## STAFF REPORT ACTION REQUIRED

### 2 Wilket Road – Zoning Amendment and Site Plan Control Applications – Request for Direction Report

<b>Date:</b>	August 18, 2015
<b>To:</b>	North York Community Council
<b>From:</b>	Director, Community Planning, North York District
<b>Ward:</b>	Ward 25 – Don Valley West
<b>Reference Numbers:</b>	14 187157 NNY 25 OZ & 14 187175 NNY 25 SA

Attachment 2: Elevations

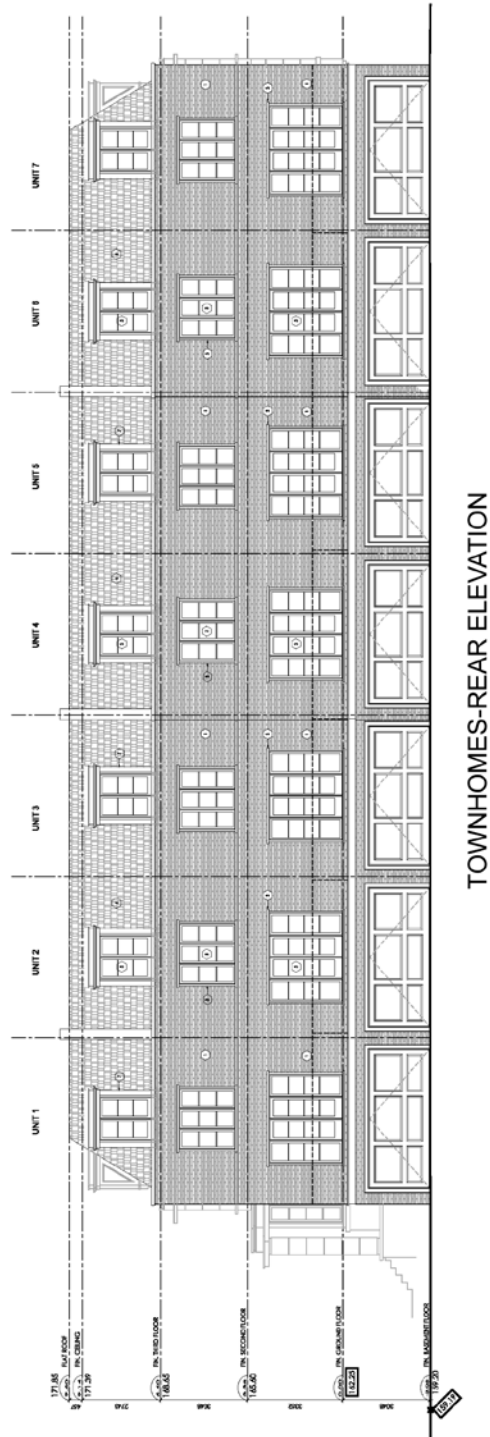
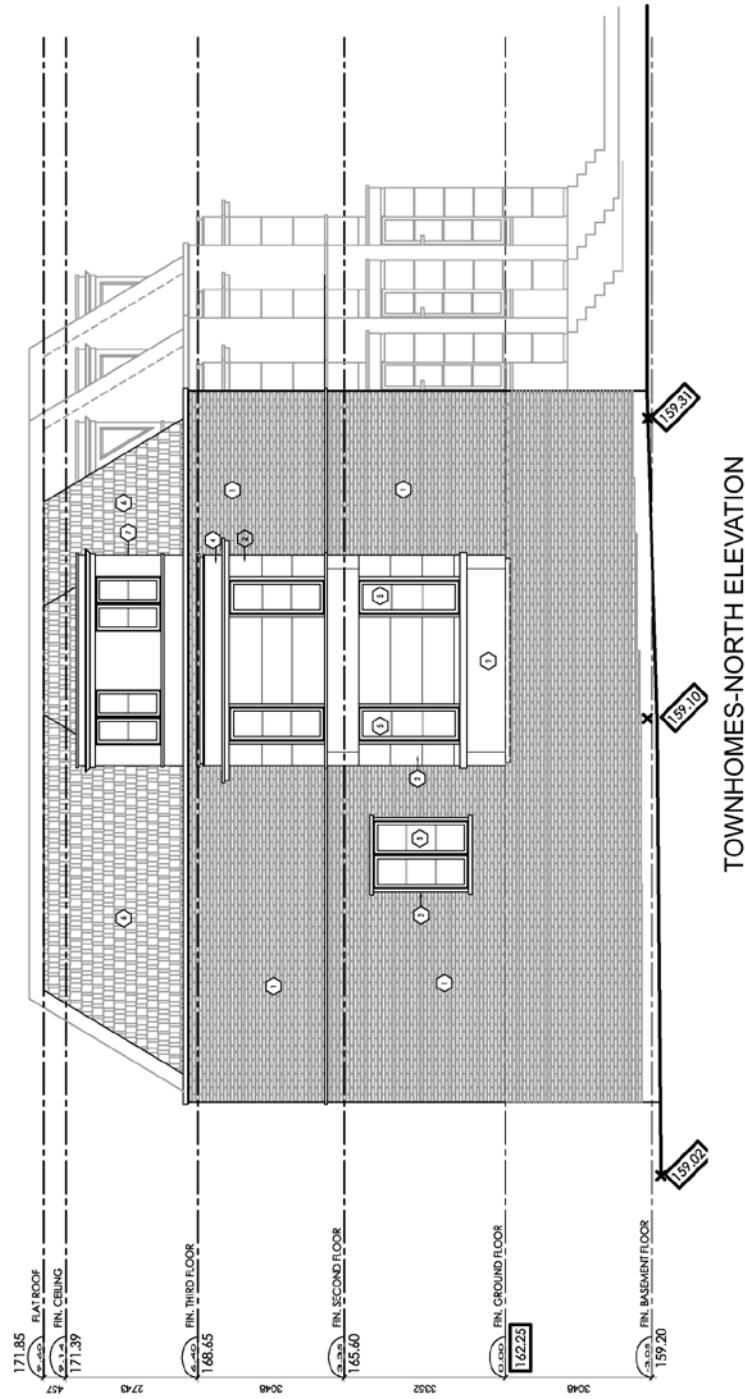
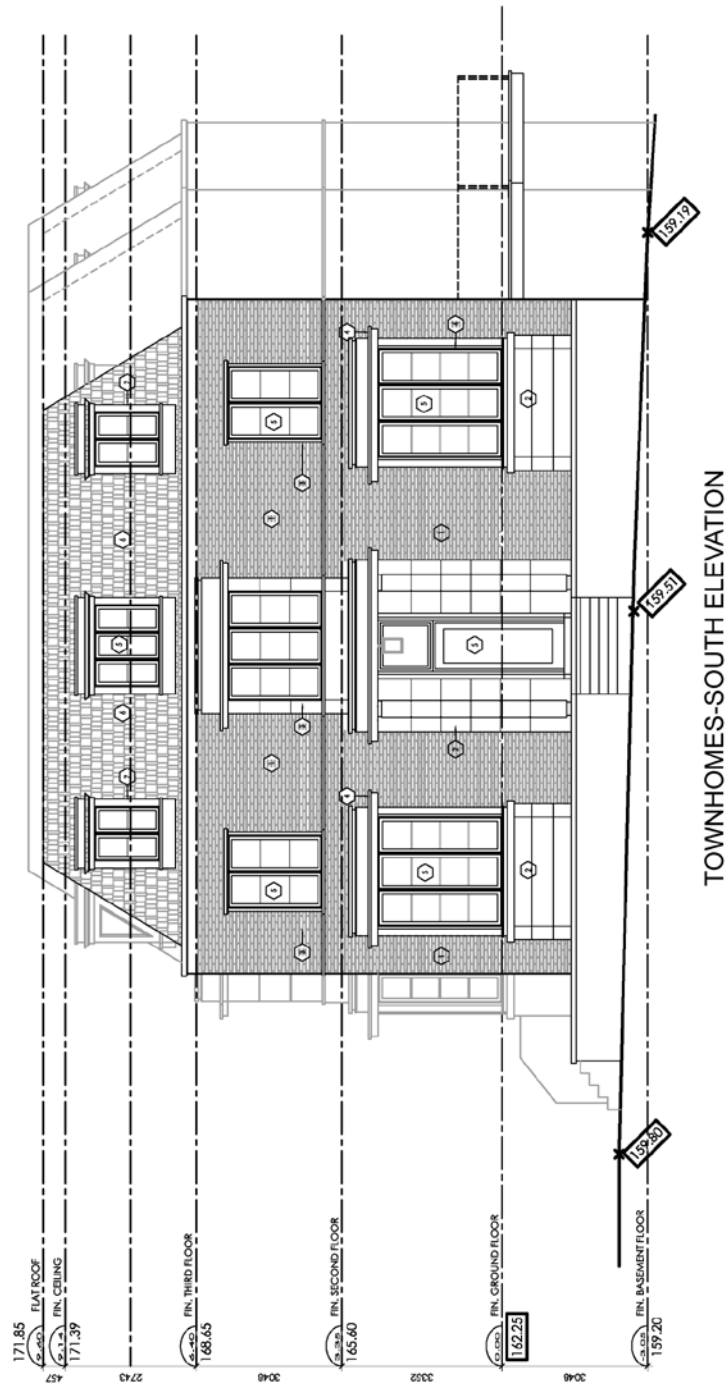
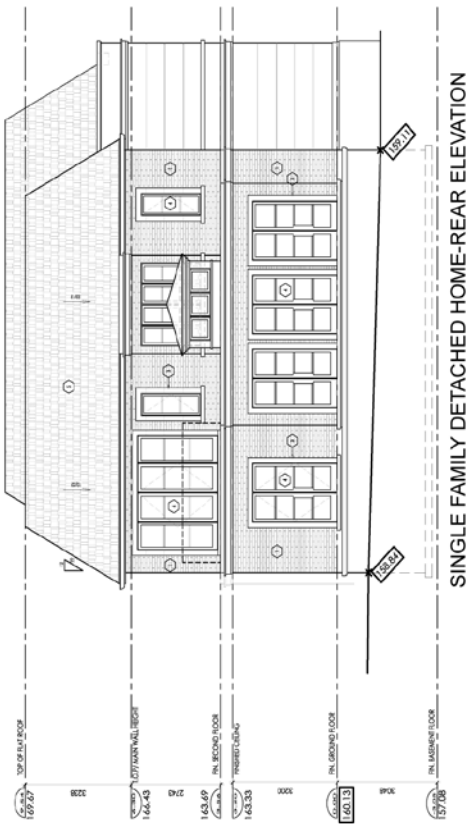
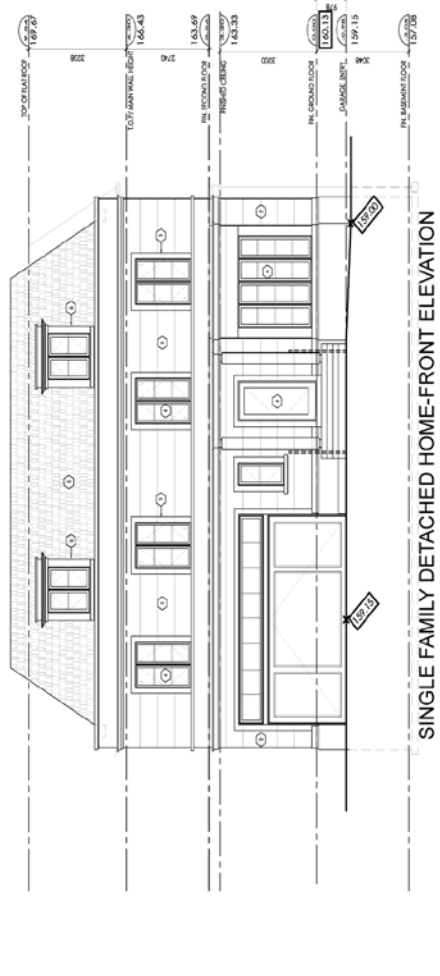
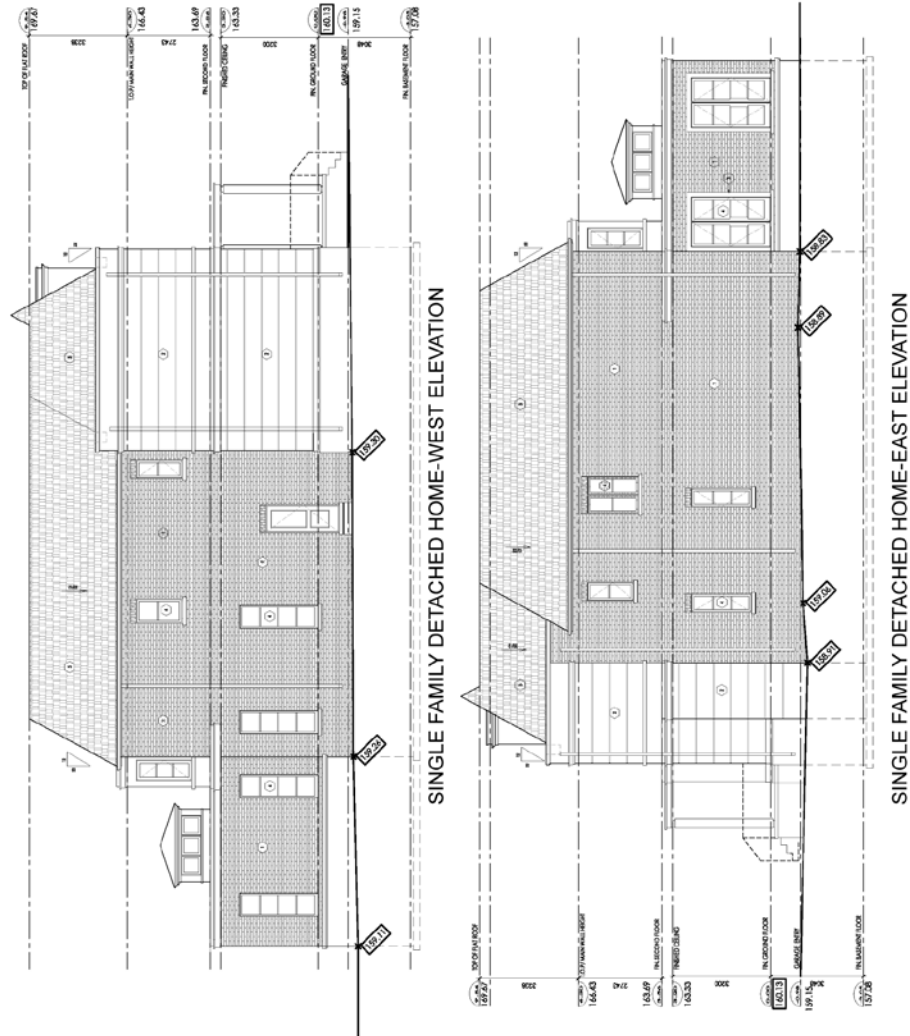
The proposed unit widths range between 5.7 and 5.8 metres which do not fit with the built form character of the neighbourhood. Each unit should be a minimum of 6 metres in width which would allow for the townhouses to better fit within the existing character. Wider units allow for larger front yards which would permit additional landscaping to respect and enhance the landscaped character of Bayview Avenue. Wider units also allow for double car garages which have space for the storage of garbage bins and other personal items.

The City's Infill Townhouse Guidelines permit a maximum first floor height of 0.9 metres however the applicant is proposing a maximum first floor height of 1.7 metres for the northerly most unit. The Official Plan policies state that units should be located so they are clearly visible and directly accessible from the public sidewalk, with ground floor uses that have views into and where possible access to adjacent streets. An entrance 1.7 metres above grade is less visible and does not create the same amount of interaction with the street. The proposed first floor height of the northerly unit should have a more

The massing of the townhouses should be improved to provide for a better integration of the new townhouses with the existing Bayview Avenue neighbourhood. This can be achieved by ensuring that the townhouses are appropriately massed and articulated to resemble the scale and articulation of a detached dwelling found on Bayview Avenue and in the interior neighbourhood. The number of townhouses within a block should be limited to ensure that the overall block size is massed to be of a similar size to a detached dwelling found within the neighbourhood.

The townhouses should be appropriately massed and articulated to resemble the scale and articulation of a detached dwelling found on Bayview Avenue and in the interior neighbourhood and high quality materials and finishes should be provided which respect and reinforce the character of the Bayview Avenue neighbourhood.
